**CHARTER TOWNSHIP OF VAN BUREN
PLANNING COMMISSION AGENDA
Wednesday, August 22, 2018 – 7:30 PM, Board of Trustees Room**

ITEM #1: CASE 18-025 – SITE PLAN APPROVAL

Subject: PC: #18-004 (SPR); Ashley Crossroads South Parking Lot Expansion; Site Plan Review #1; 41775 & 41873 Ecorse Road; Site plans received on July 24, 2018.

Re: Crossroads Distribution Center – South Building No. 1 Parking Lot Expansion
South Side of Ecorse Road, West of Haggerty Road, Section 2

1 INCH = 200 FEET
WEI PROJECT No. 14-156
WCDS REVIEW No. R16-498
C1
SITE PLAN

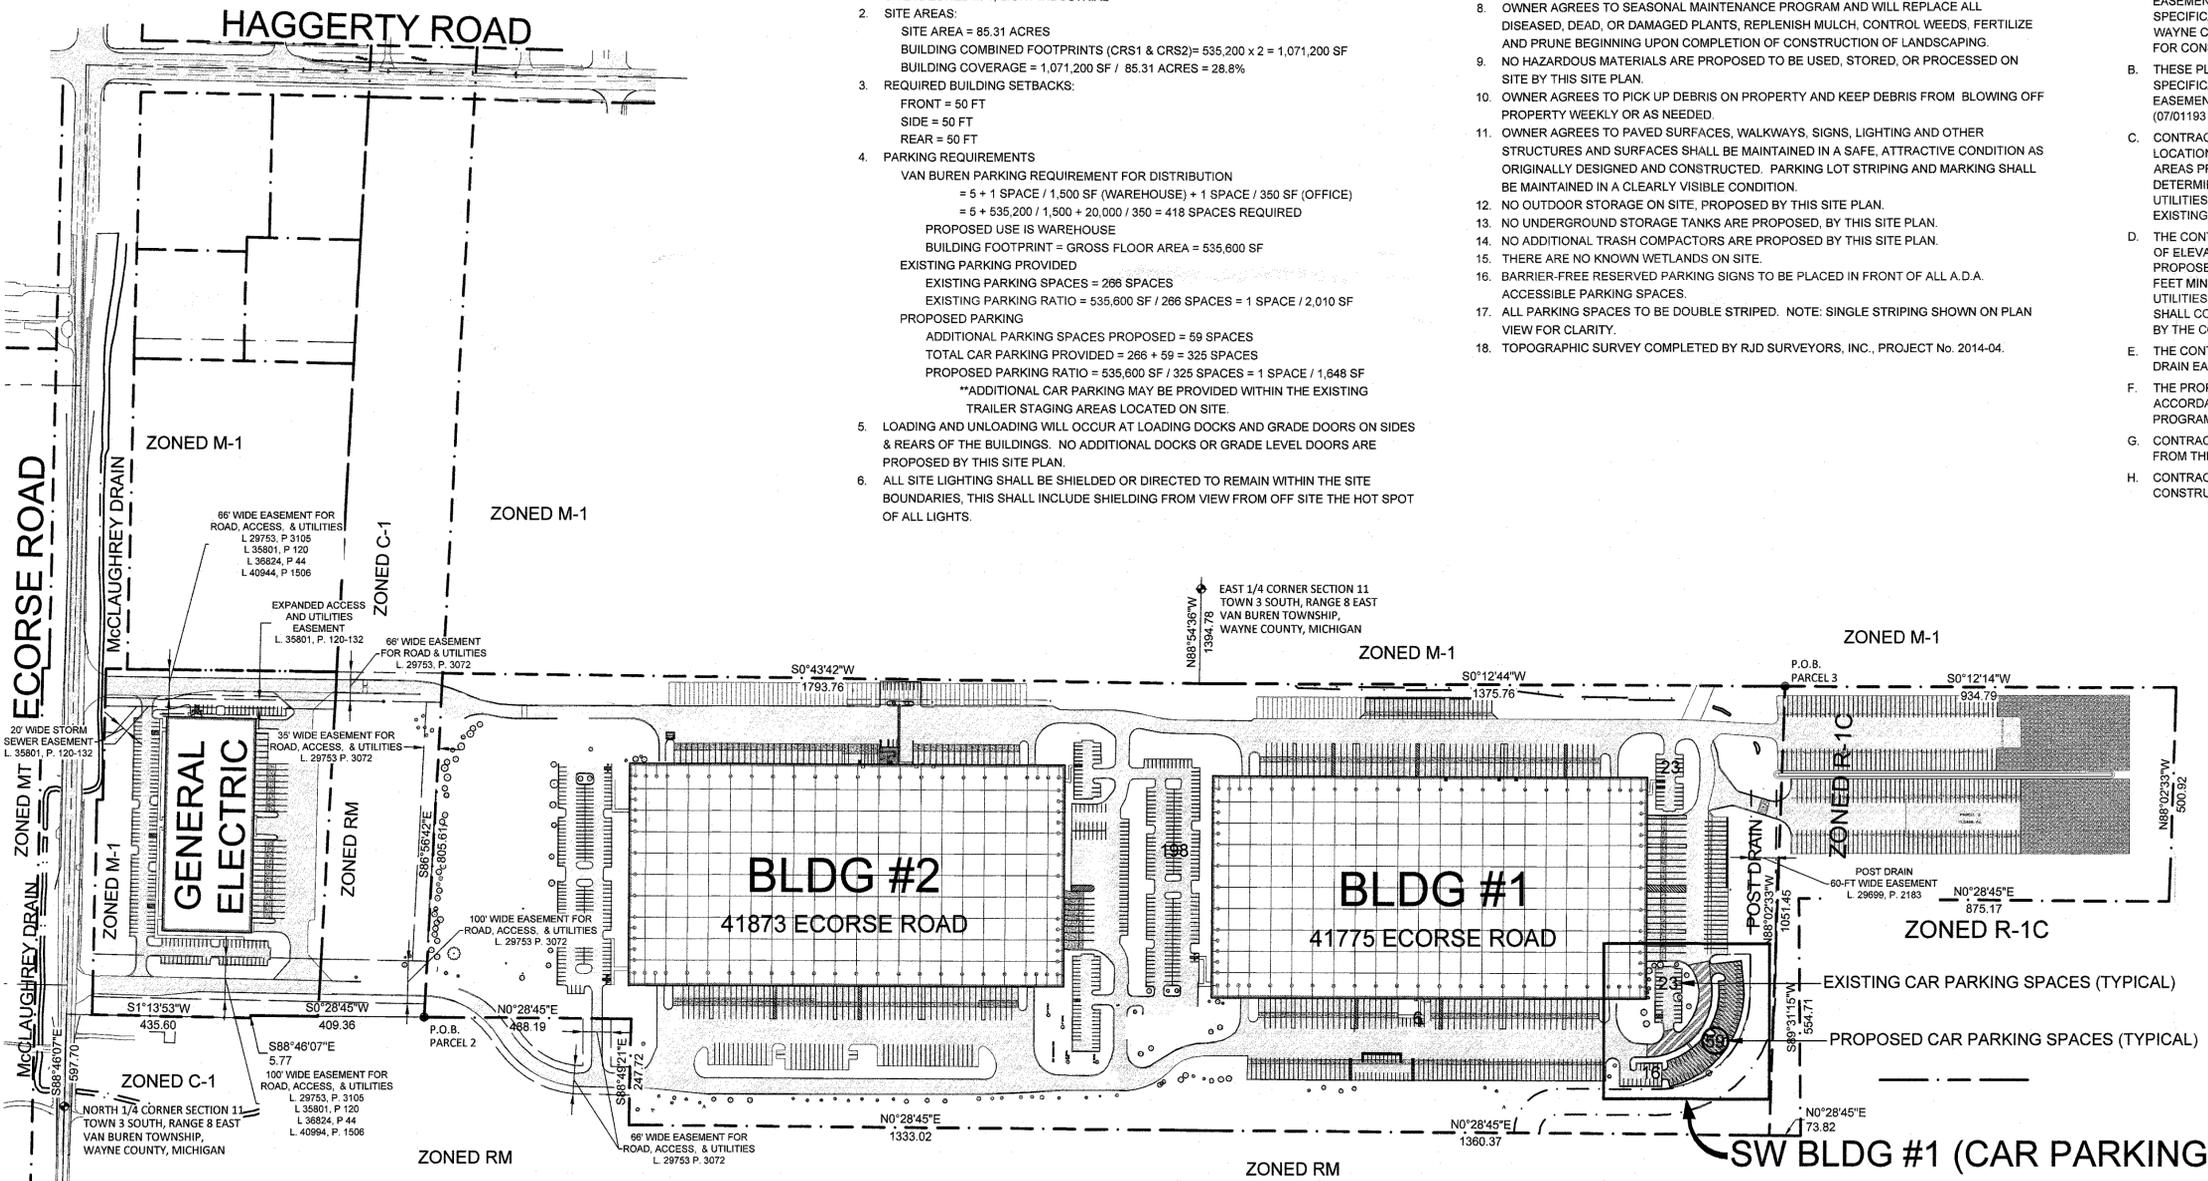
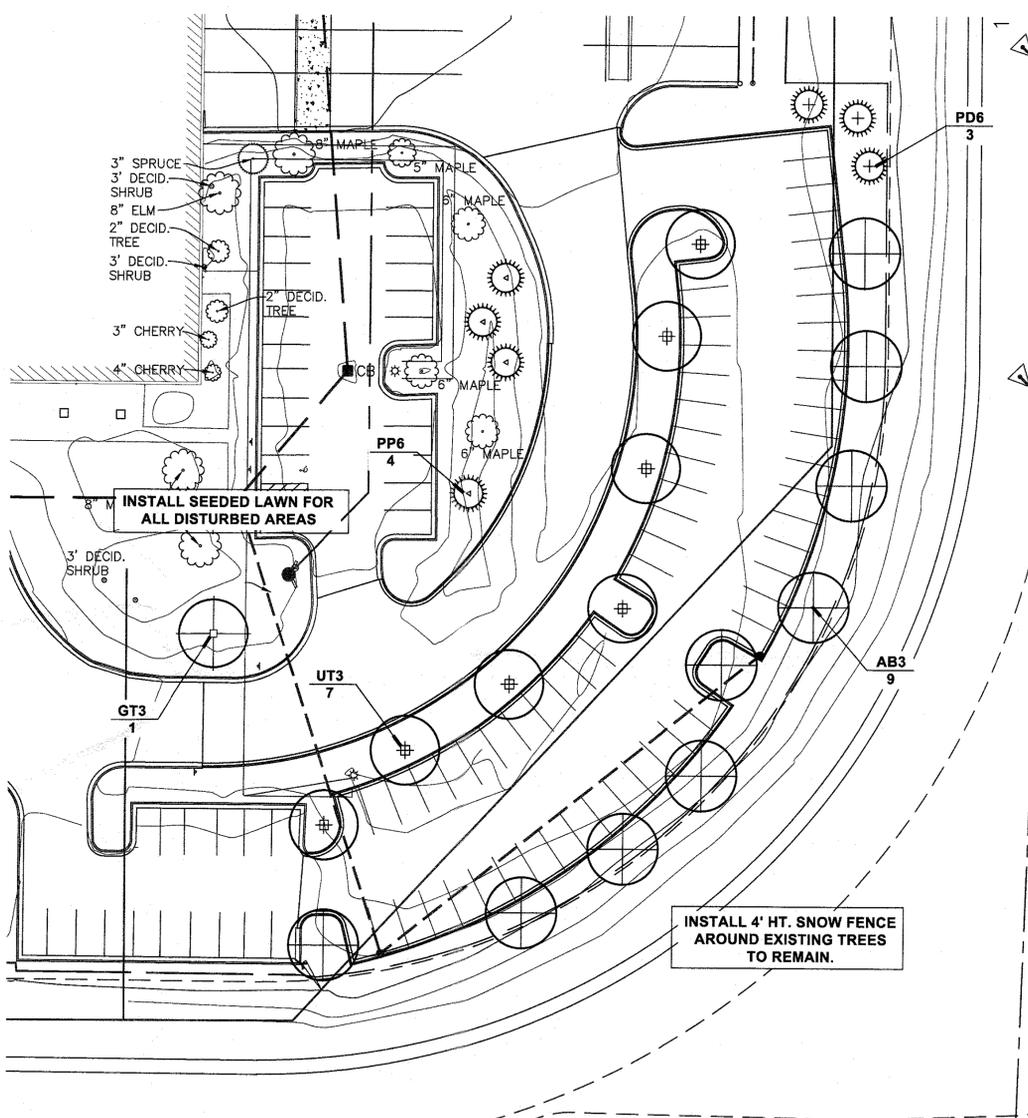
Sheet C1 of the plans must be updated to correct the minimum setback requirements.

1. That Sheet C1 of the plans be updated to correct the minimum setback requirements.
2. That all proposed parking spaces be double striped per Section 9.104(C) of the Zoning Ordinance and that Sheets C2 and L1 be revised to show the required double striping.

L1
LANDSCAPE PLAN
1 INCH = 30 FEET
DPD PROJECT # 91495

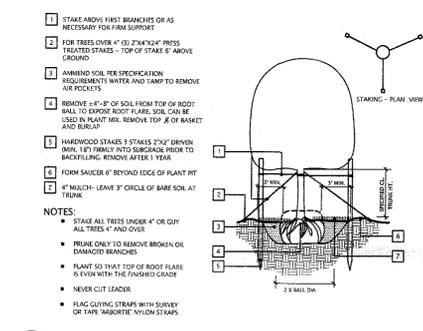
5. **Landscaping and Screening.** Landscaping is subject to the provisions of Section 10.103 of the Zoning Ordinance. Sheet L-1 of the site plan submission includes details of proposed landscaping for the site. The Zoning Ordinance describes the landscaping requirements that must be met individually, and our comments on the applicable requirements (Interior Parking Lot Landscaping, Greenbelt Buffering, and Tree Replacement) are as follows:

a. **Interior Parking Lot Landscaping.** Section 10.103(B)(2) of the Zoning Ordinance requires parking lot landscaped areas to be at least 5% of all the paved areas. The site plan shows new vehicular surface area as 29,479 square feet, thus requiring 1,474 square feet of landscaped area. There is more than 1,474 sq. ft. of interior landscape area added, so this requirement is met.

Each landscaped island must be at least 360 square feet and shall have at least one (1) tree. Also, there must be at least 1 tree per 300 square feet of vehicular surface landscaped area. The parking lot islands comply with this requirement and 15 trees are proposed for interior parking. The height of the evergreen trees must be at least 8 feet, pursuant to Section 10.104(B) of the Zoning Ordinance.

b. **Greenbelt Buffering.** Section 10.103(E) requires screening between a use on an M-1 zoned property and abutting single family residential districts. The Zoning Ordinance requires a 60-foot wide buffer with a double staggered row of evergreens placed 15 feet on center, with a flat horizontal crest area of at least 3 feet. Although the existing greenbelt to the south is outside of the project area and pre-dates the current greenbelt buffering requirement of the Zoning Ordinance, we recommend that the existing greenbelt area be illustrated on the plans. We also recommend that additional evergreen trees be planted in the buffer area south of the proposed parking lot in accordance with Section 10.103(E) if there is sufficient area to plant additional evergreen trees in the buffer/berm area.

c. **Tree Replacement.** Sheet C-2 shows the removal of 9 trees, and Sheet L1 shows the planting of 9 replacement trees. While the sizes and species of the 9 trees to be removed are not included on the plans, these trees are assumed to be protected trees that require replacement pursuant to Section 8.106 of the Zoning Ordinance. Therefore, this requirement is met.

7. That a lighting plan and photometric plan for the proposed parking area be submitted that meets the requirements of Section 154.030.
 8. That the height of the evergreen trees be increased to at least 8 feet, pursuant to Section 10.104(B) of the Zoning Ordinance.

9. That the existing greenbelt area located south of the proposed parking lot be illustrated on the plans, and that additional evergreen trees be planted in this greenbelt area in accordance with Section 10.103(E) if there is sufficient area to plant additional evergreen trees in the buffer/berm area.
